INLAND FISHERIES AND WILDLIFE NATURE PARK - ADDENDUM #1

date: May 13, 2024
project: Inland Fisheries and Wildlife Store and Admin Office Project # 3096
prepared by: Ryan Kanteres Simons Architects
Adam Wiles-Rosell Simons Architects
Mikayla Molta Simons Architects

Subject: **Addendum #1** to Bid Documents of April 23, 2024

A101

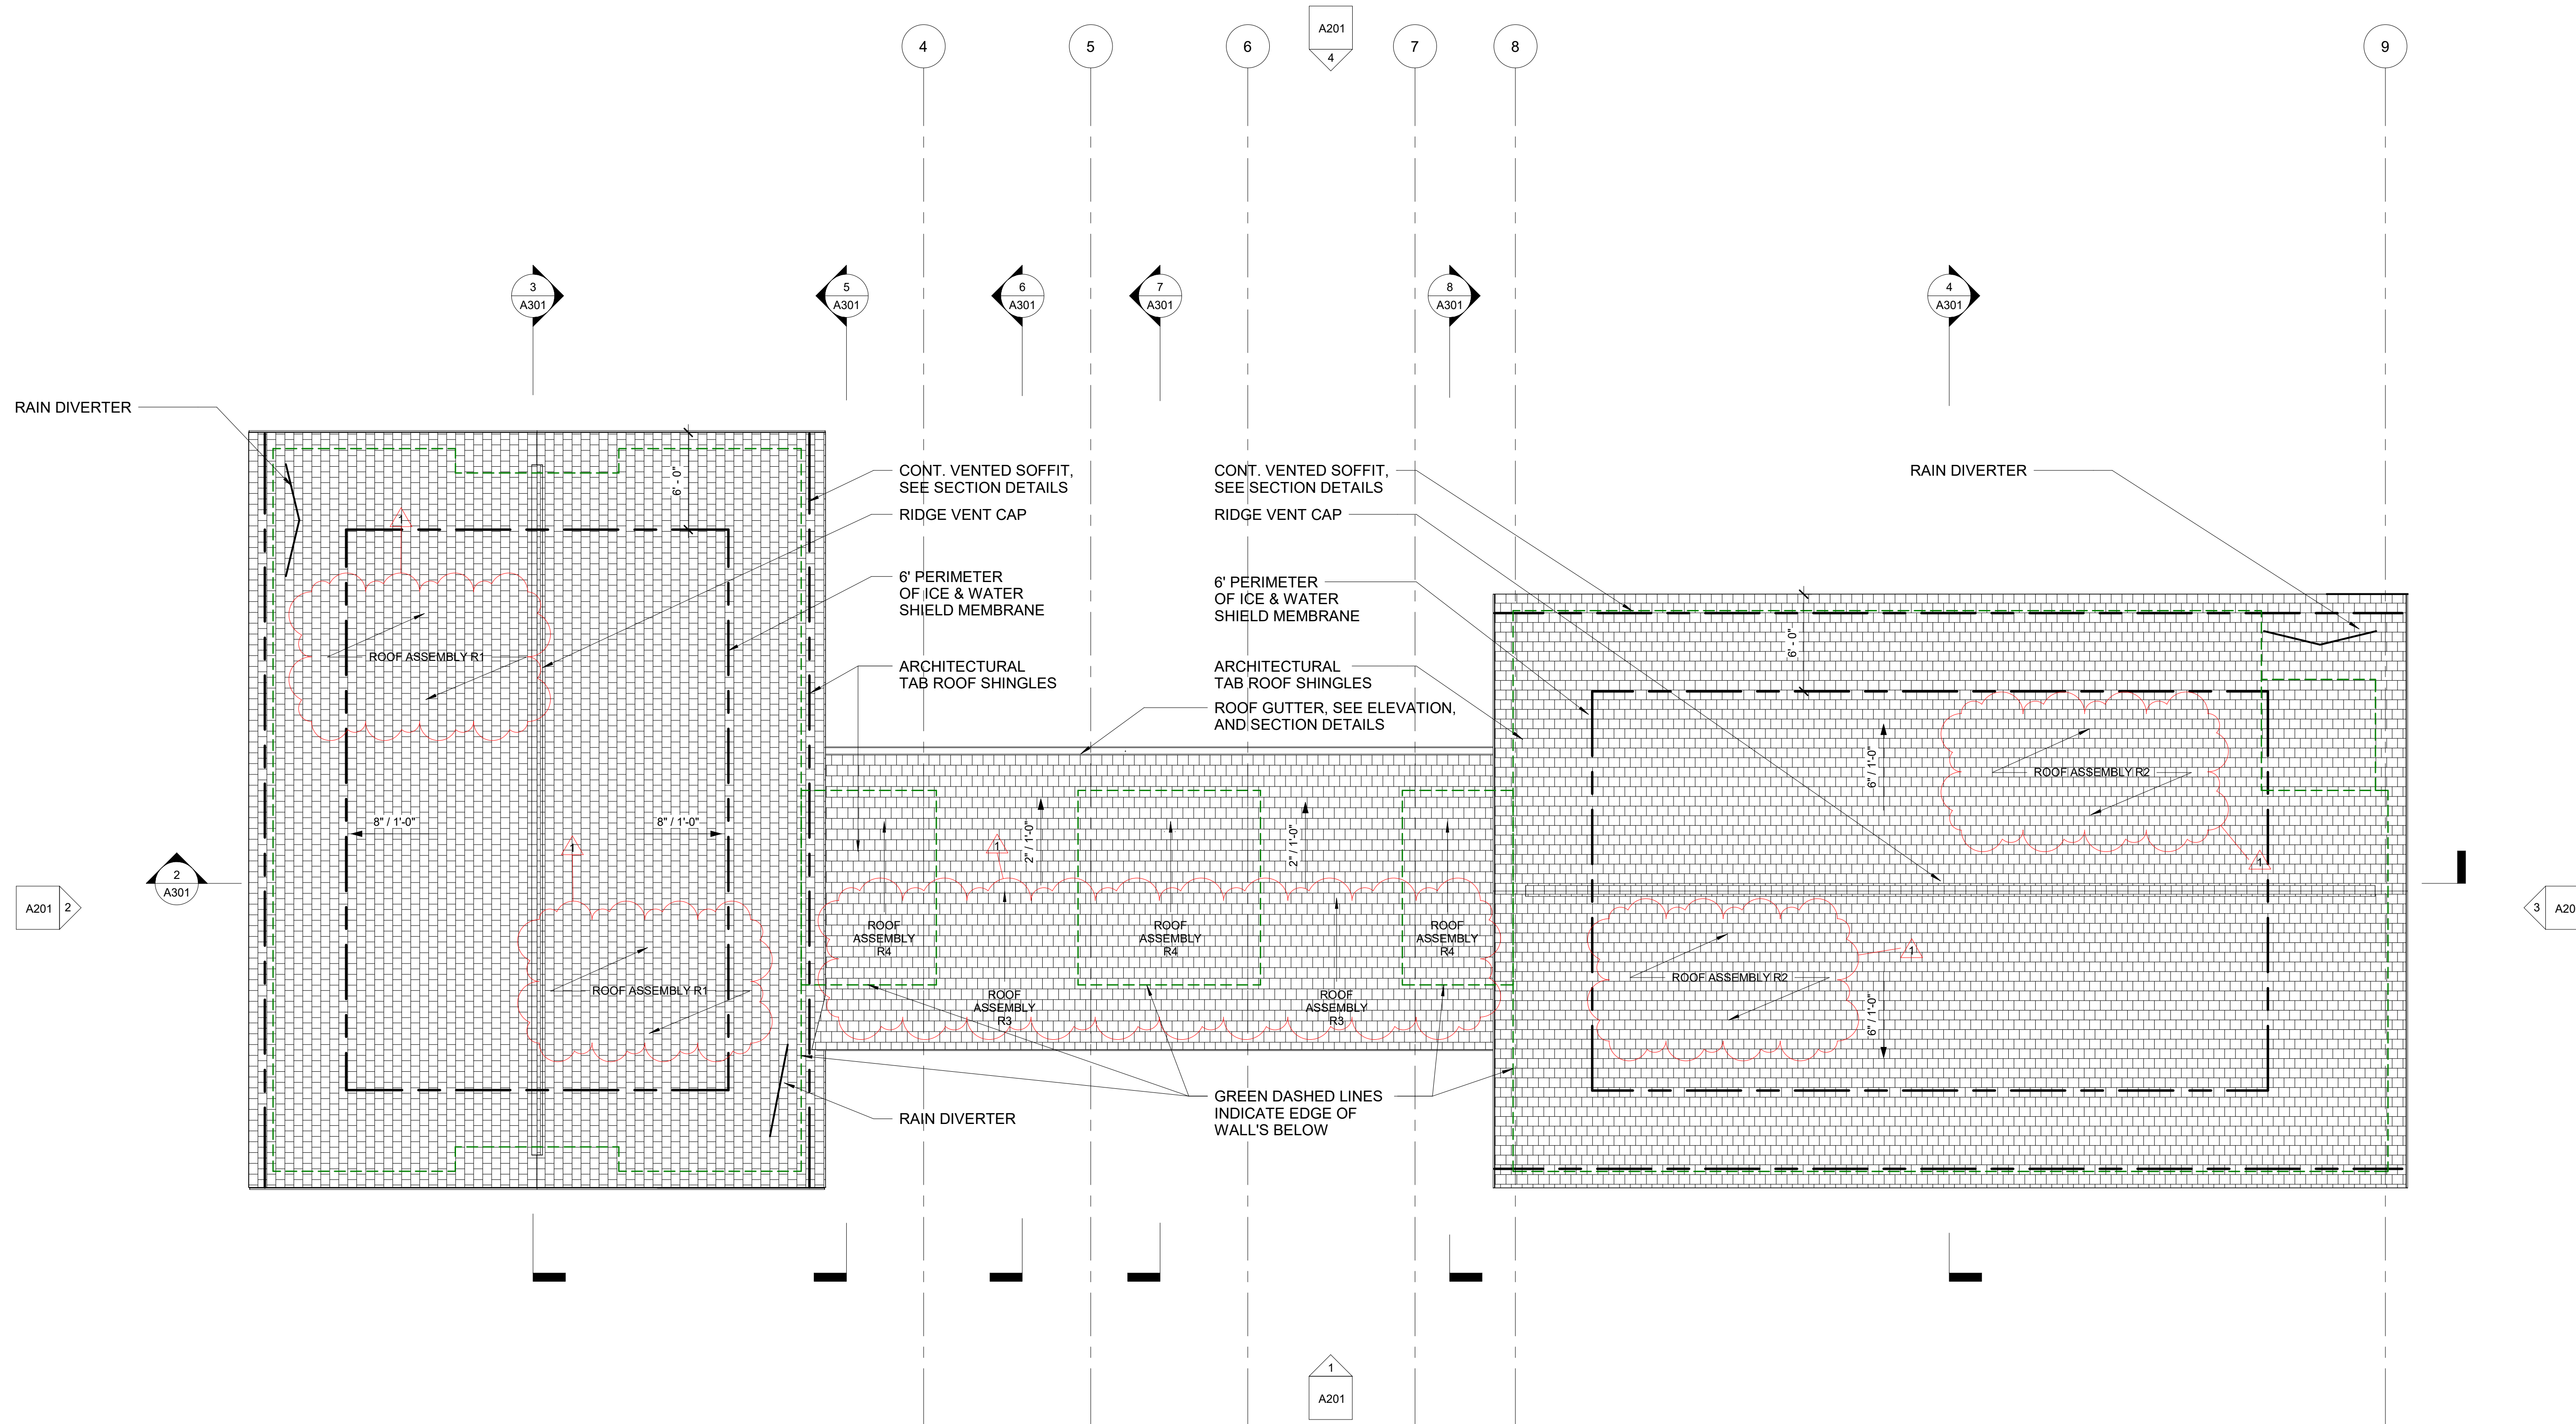
1-D6 Sheet A101 Relocated ADA push paddle and door operator to vestibule 106 from vestibule 113, located fire extinguisher cabinets, clarified window tagging for Nature Store.
